LINOTYPE IMPROVEMENT INFORMATION SHEET

NO. 343

DELIVERY SLIDE TIGHT LINE SAFETY

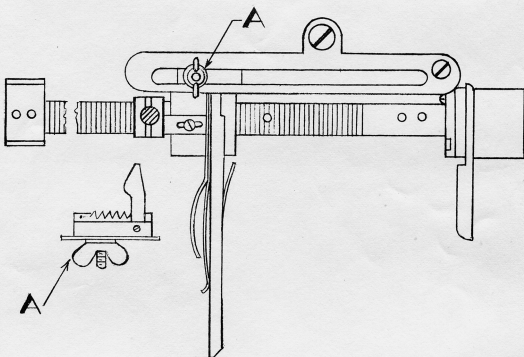
A new mechanical tight line safety for tape operated Linotypes has been designed to prevent tight lines from being delivered to the first elevator jaws. This safety can be adjusted so that a tight line will not pass between the long and short delivery slide fingers which will automatically stop the operating unit.

The delivery slide tight line safety is supplied as a component part of the TTS Safeties Attachment which is optional equipment on new Linotypes. The new tight line safety eliminates the need for the assembling elevator latch solenoid which will no longer be supplied as part of the TTS Safeties.

Can be applied to outstanding Linotypes with Self-Locking Delivery Slide (serial No. 55835 and up) as part of the TTS Safeties Attachment, or as a separate unit (part 38-0340-01).
